Docket Item # 1 & 2
BAR CASE # 2012-0070 & 0071

BAR Meeting
April 18, 2012

ISSUE: Permit to Demolish &
Certificate of Appropriateness for Alterations

LOCATION: 501 South Royal Street

Figure 1: Plan/Details for proposed Door

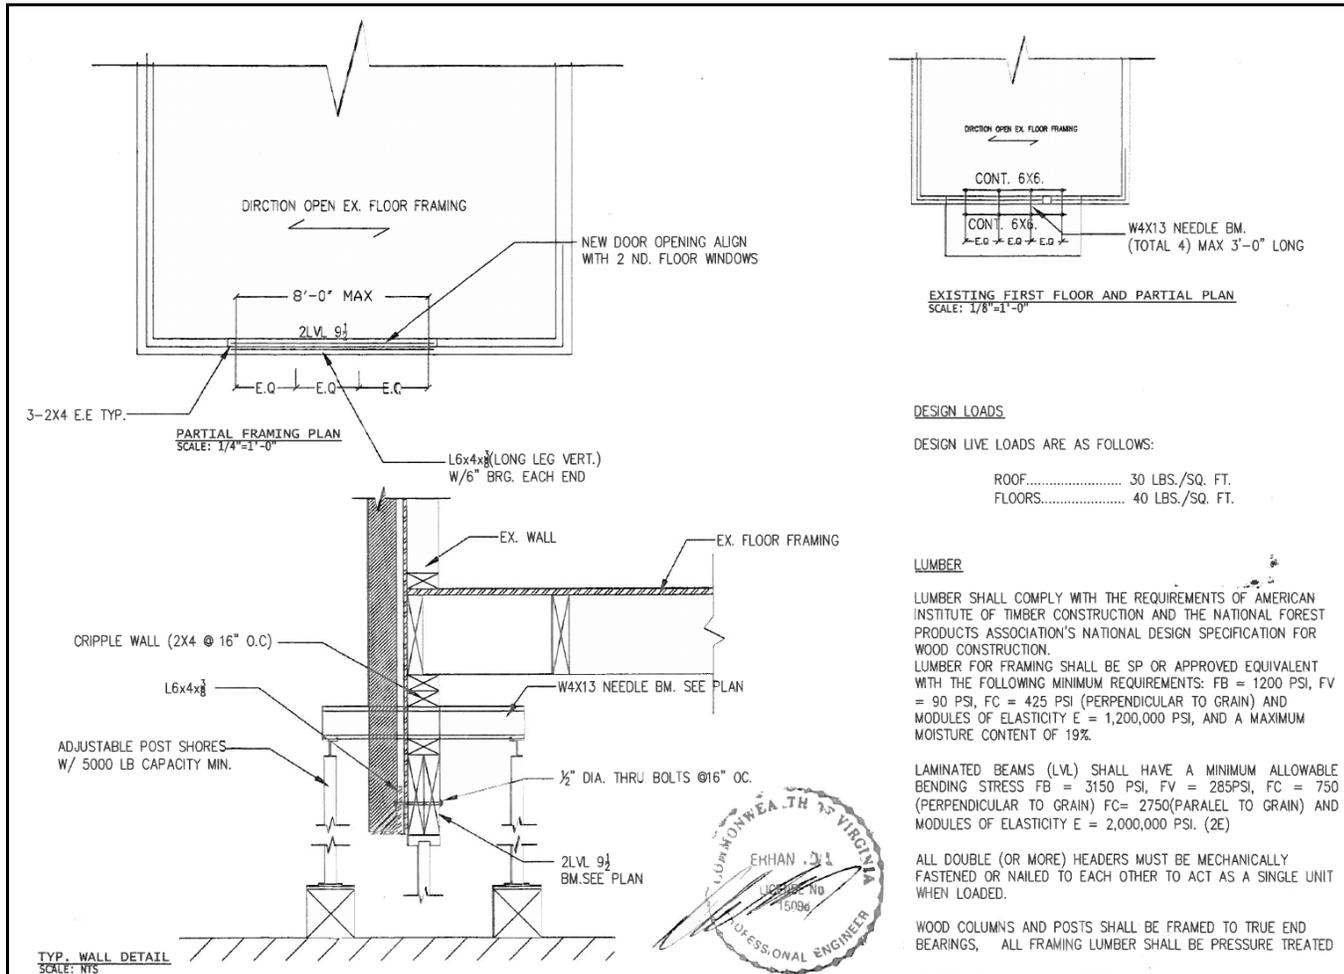
The *Design Guidelines* state that "Exterior doors and surrounding details should be appropriate to the period of the structure." The applicant is proposing to utilize a fiberglass door with a painted, wood Colonial Revival surround. Staff supports the proposed alterations, noting that the proposed door installation and materials are consistent with the *Design Guidelines*, as the exterior door and its surrounding details are compatible with the architectural style and late 20th century period of the building. In addition, staff also supports the utilization of a paintable, solid-through-the-core wood composite material for the door surround instead of the proposed wood, at the applicant's option, as this new door will be located on the rear of the building and only minimally visible from the ROW.

STAFF RECOMMENDATION: Staff recommends approval of the Certificate of Appropriateness with the condition that the applicant may utilize either wood or a paintable, solid-through-the-core wood composite material for the door surround in lieu of the proposed painted wood surround.

Figure 4: Proposed location of New Door

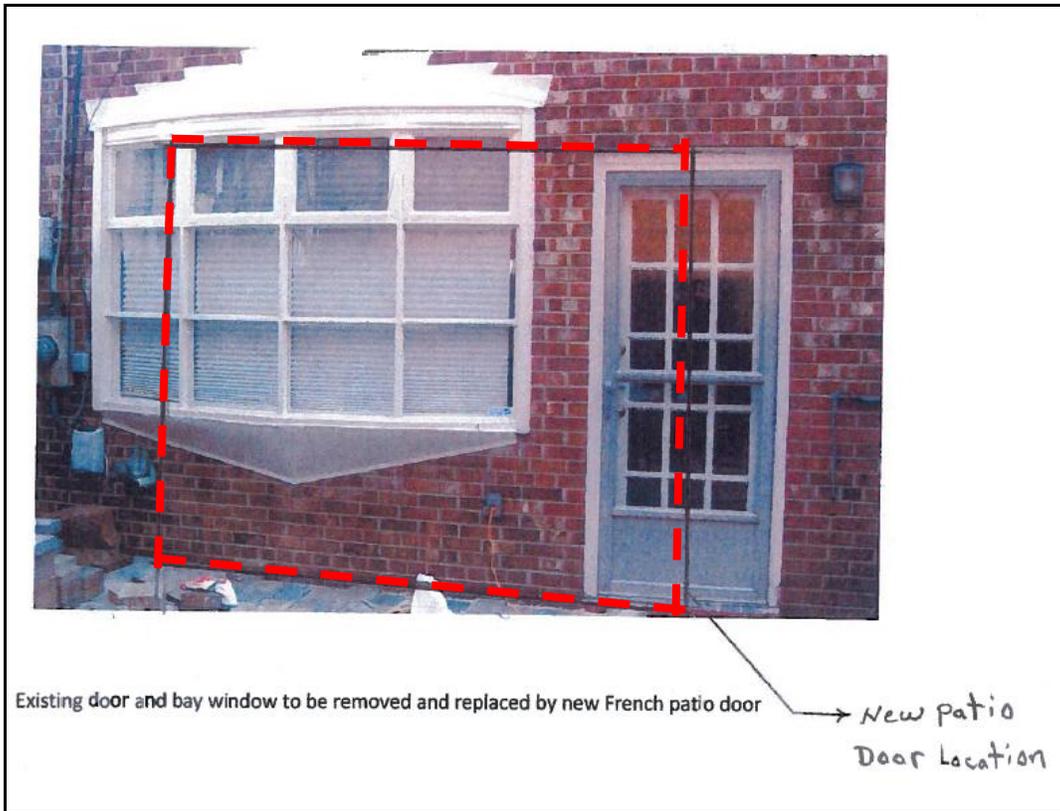
The scope of the proposed demolition of the building exterior is minimal. The removal of the existing bay window and door and the installation of a new set of full-light doors on the rear elevation is a common and typical type of alteration that allows buildings throughout the historic districts to be reconfigured for contemporary lifestyles without negatively impacting the overall architectural integrity of the building or the surrounding streetscape. Staff has no objections to the removal of these minor features as they do not contribute to the significance of the building. The construction materials proposed for demolition are commonly available and were installed without a high degree of design or craftsmanship.

Staff finds that the proposed demolition of the existing bay window and door and the new door installation in this location is a sensitive and minimally visible alteration that is consistent with the *Design Guidelines*. Staff recommends approval of the Permit to Demolish and Certificate of Appropriateness as submitted.
